Elkhorn 40-Residential Development

1st Submittal

CITY OF LAS VEGAS		DATE:
INTER-OFFICE MEMORANDUM		September 20, 2016
TO: Land Development Services Department of Building & Safety		FROM: Albert Sung, P.E. Flood Control Project Engineer Department of Public Works
SUBJECT:	Drainage Study for:	
	Elkhorn 40 – Residential Development	
Cross Streets:	SEC of Elkhorn Road & Tenaya Way	
File Number:	F:\Depot\DSMemos\DS4823A.doc	
Parcel Number:	125-22-501-001	
Zoning Action:	TMP-65275; ZON-63488; WVR-65331; WVR-65593 & Variances	
FEMA Flood Zone	YES	NO X
Proposed Storm Drain	YES	NO X
		COPIES TO: Triton Engineering D.R. Horton, Inc. Bart Anderson, P.E., DevCo CCPW

FIGURE 3

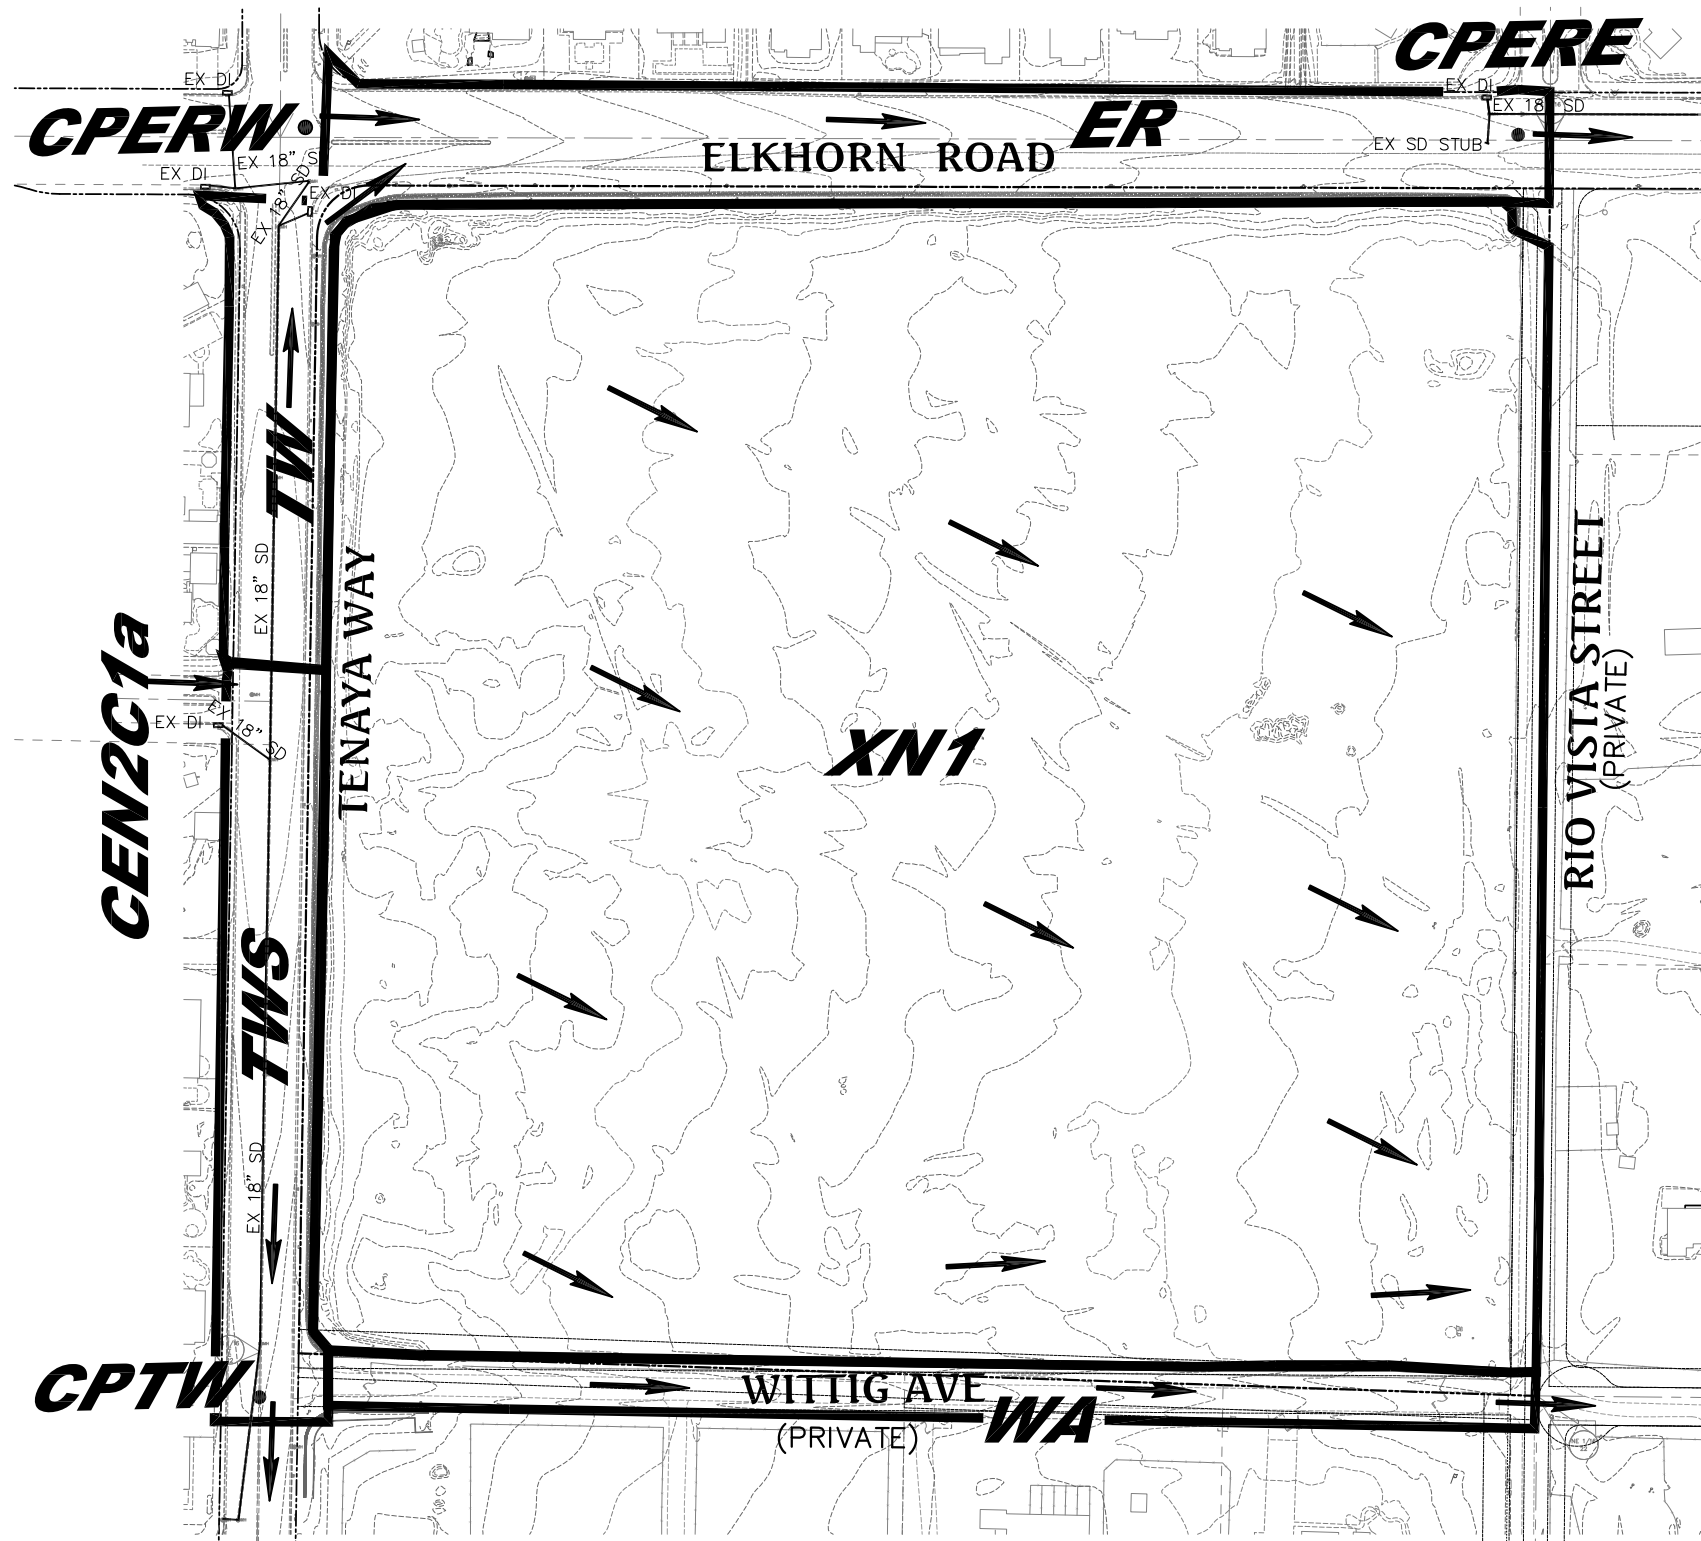
4. A concentration point valuation at the intersection of *Rio Vista Way* and *Wittig Avenue* was missing in the *Existing and Developed Conditions Drainage Map* (**Figure 3** and **Figure 4**). Provide as such in the next submittal so that a comparison of drainage impact to the neighborhoods prior to and post development can be determined.

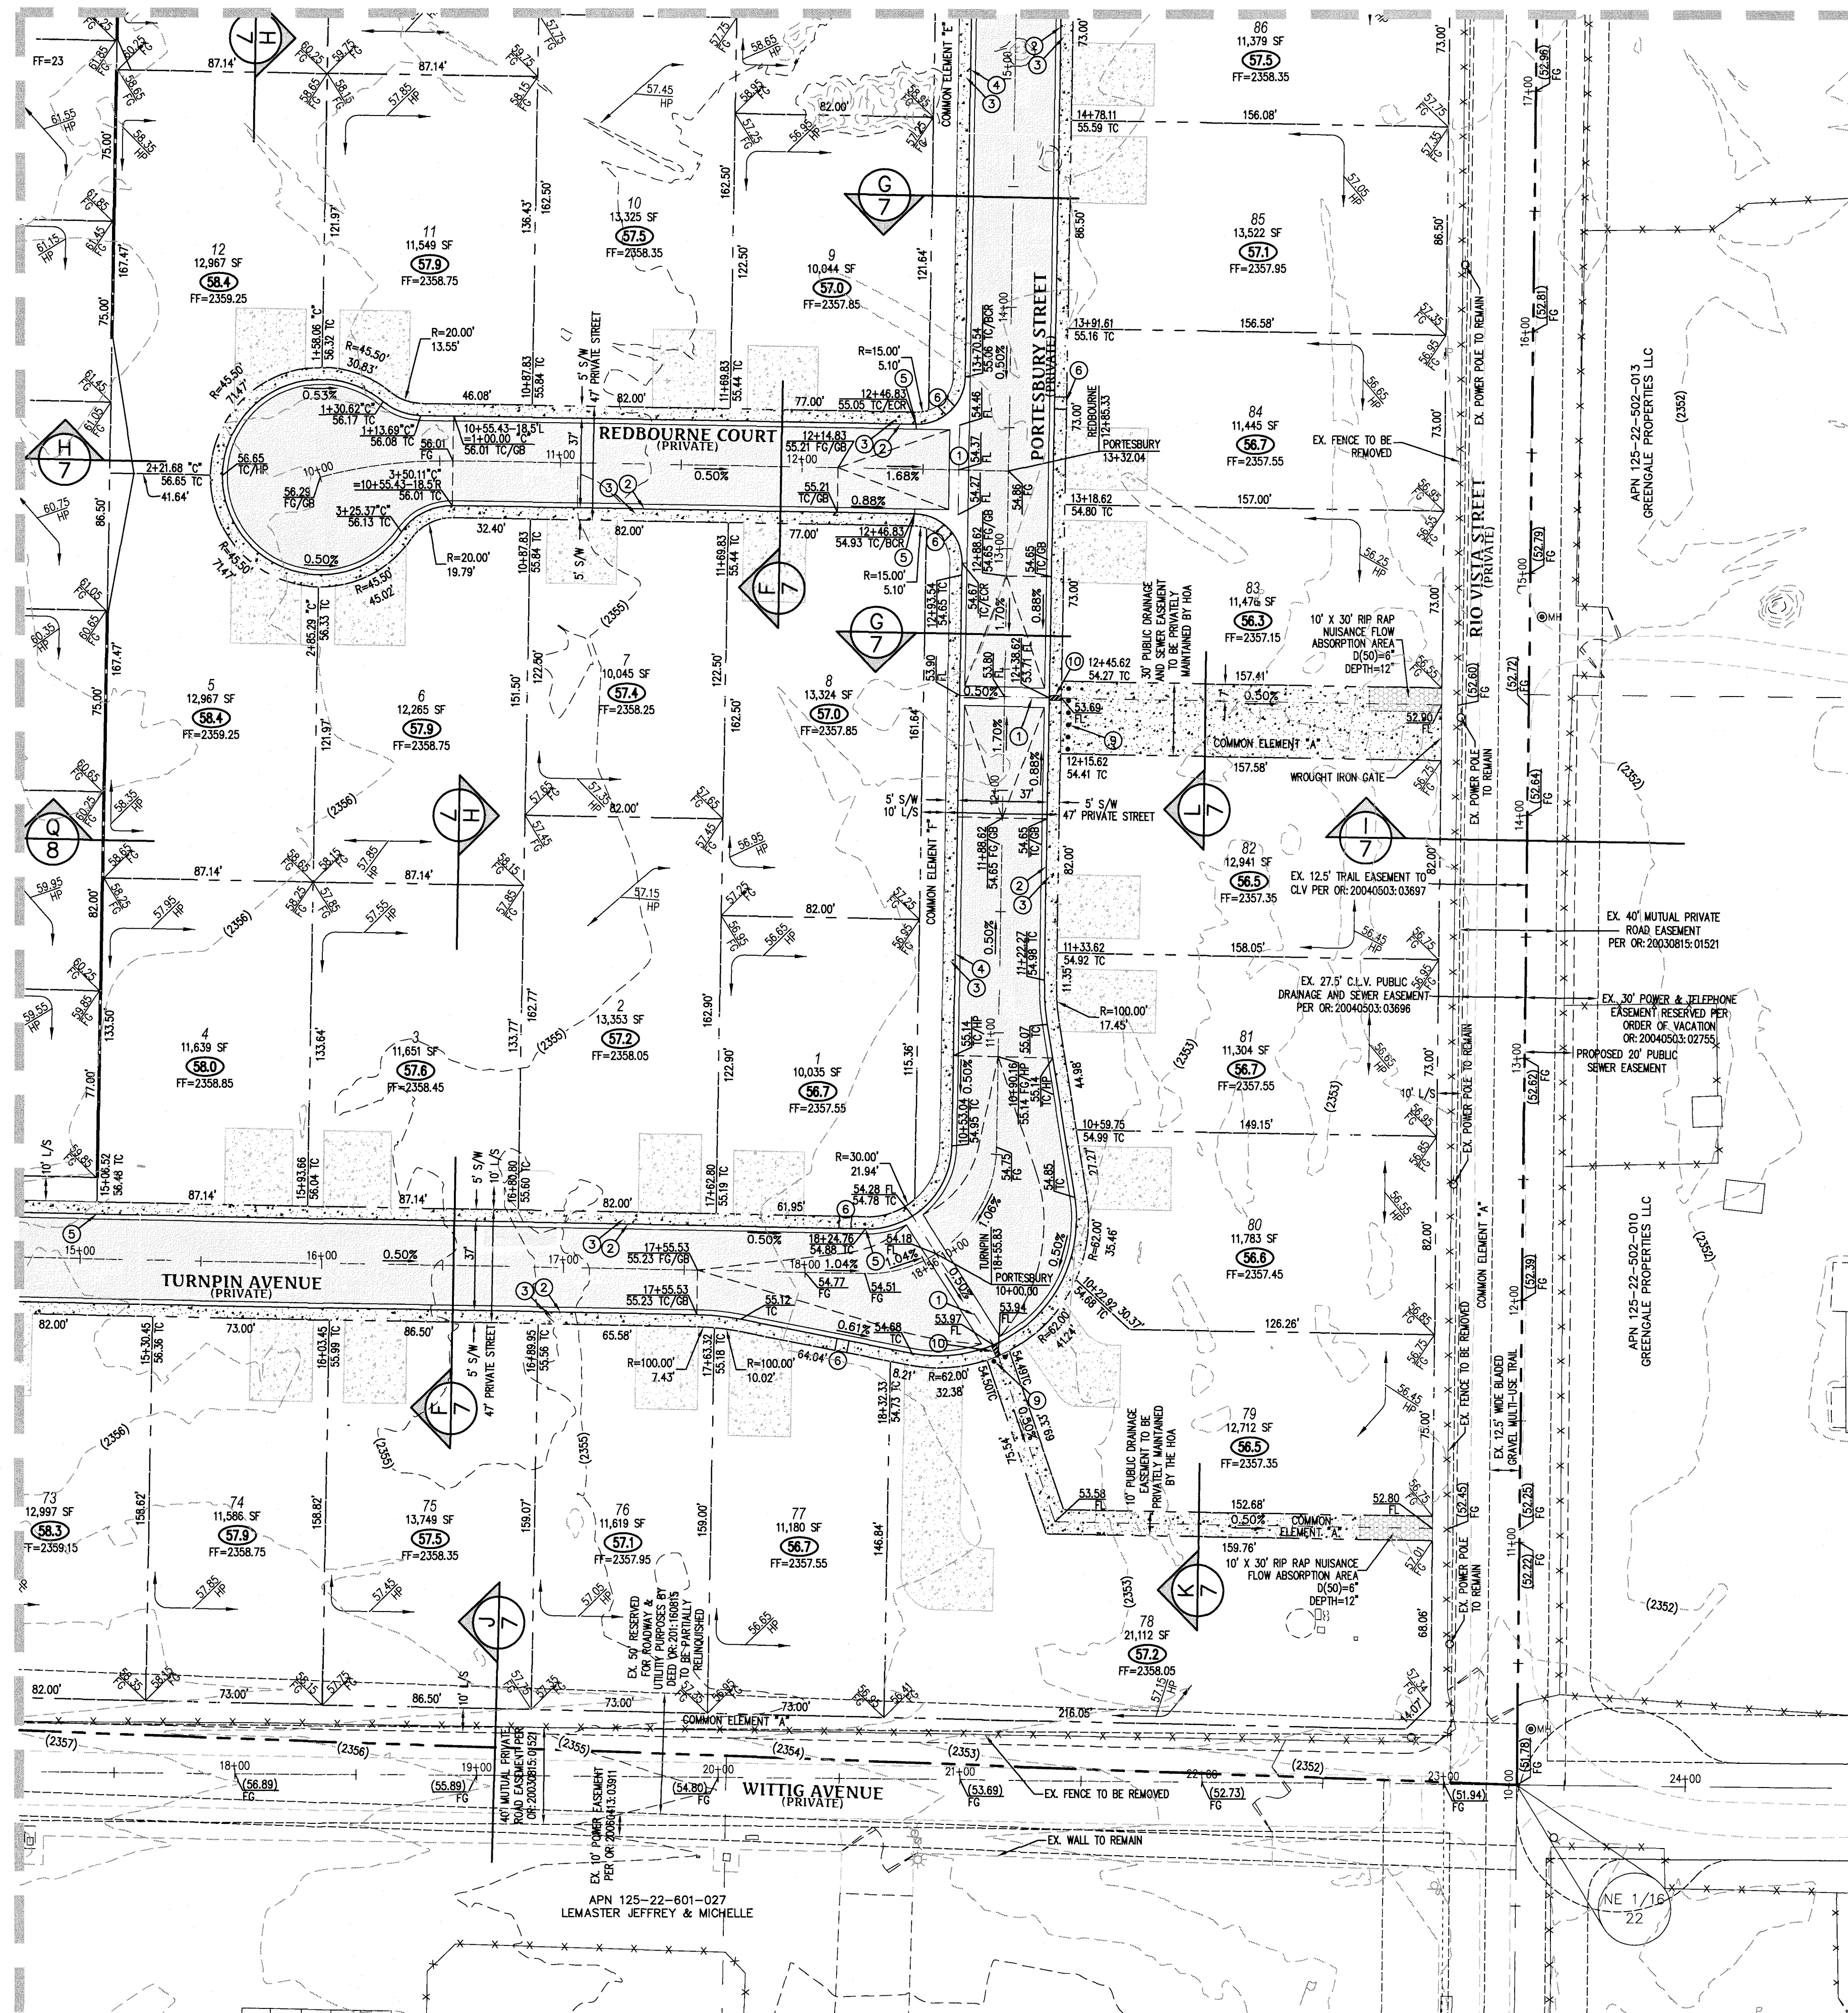
Address what needs to be done to a reach of storm drain connecting existing SDMH #504 and SDMH #506 which appears to connect to nowhere.
9. **Sheet 5 (Grading Plan III)**: Provide a nominal drop inlet in *Tenaya Way* with an 18”-lateral and connect to an existing SDMH #790. Revise the grading plan and all pertinent storm drain plans accordingly.
10. **Sheet 6 (Grading Plan IV)**: In the two common elements and public drainage easements, remove the proposed riprap to concrete lined the whole element.
